Reference: **ACCESS REPORT – STATE SIGNIFICANT DEVELOPMENT APPLICATION (SSDA)**
MUDGEES HOSPITAL

**MUDGEES HOSPITAL
MEARES STREET
MUDGEES, NSW 2850**

Revision **[B]**

Document Type: Access Report

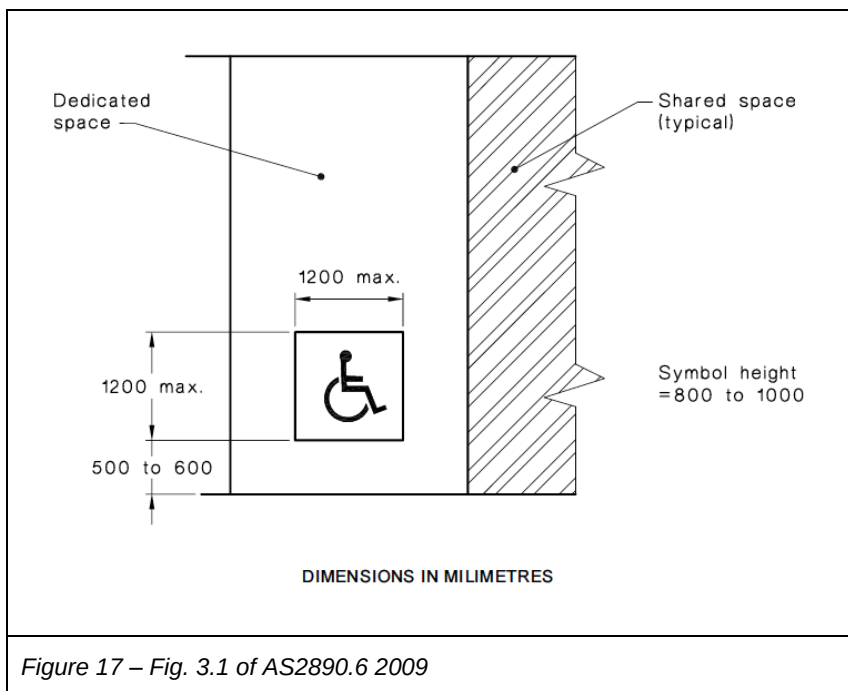
Carparking is shown in the overall ground floor plan, indicating the adjacent public carpark with the inclusion of what appears to be six (6) accessible carparking spaces.

The minimum number of accessible parking spaces will need to be provided in accordance with the provisions of NCC Table D3.5.

Figure 49 – Extract from Ground Floor Plan

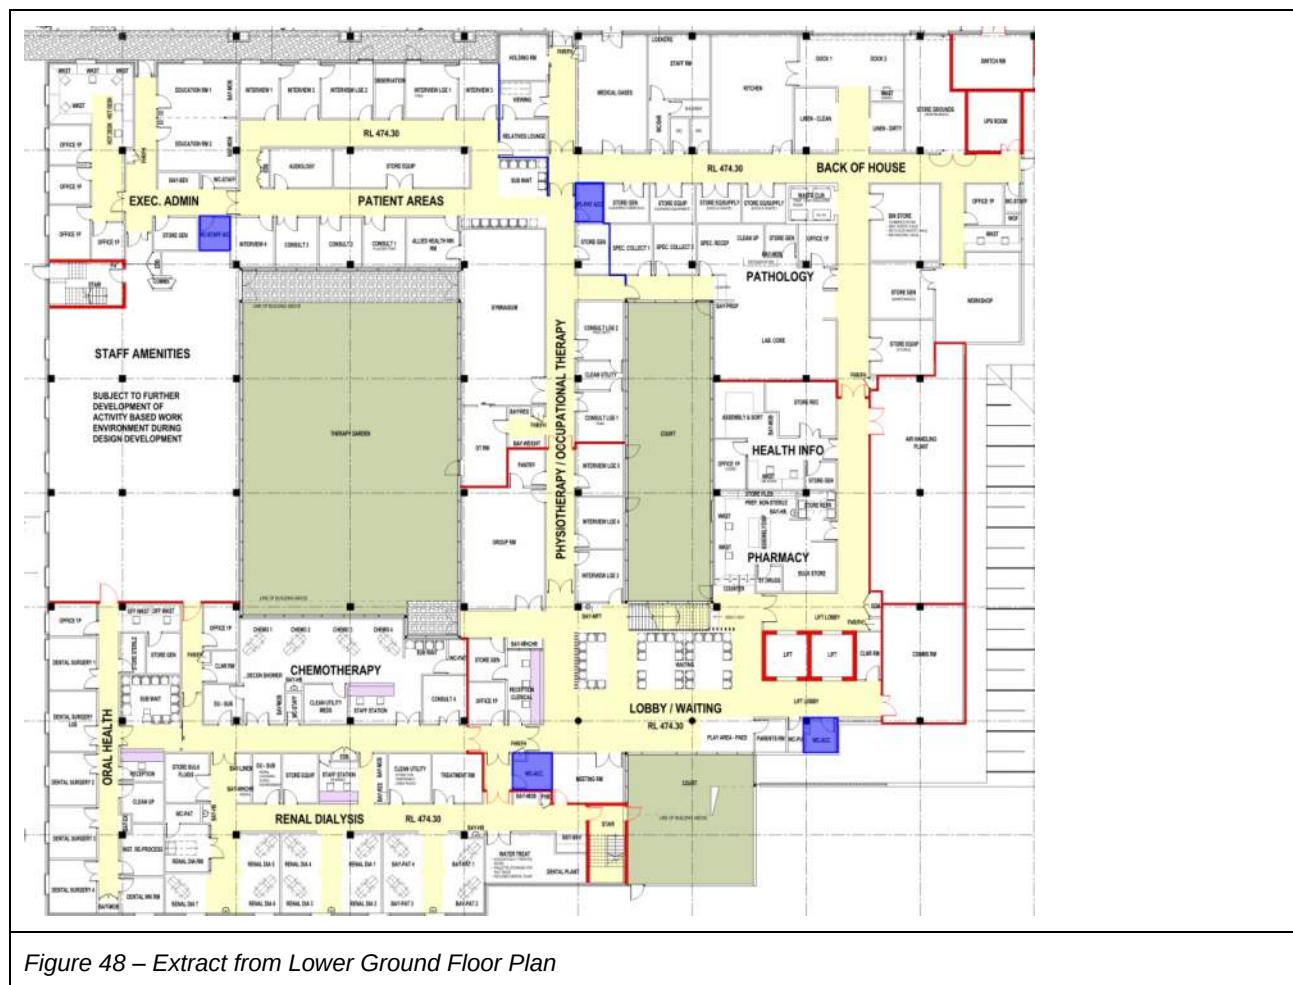
There are several accessible sanitary facilities within the new building. The mark up of the plan indicates a number of areas where WC facilities are planned to be provided.

The drawing set does not reflect compliance with this requirement. Additional Information to be provided prior to the issue of the Final Access Certification and Crown Certificate.
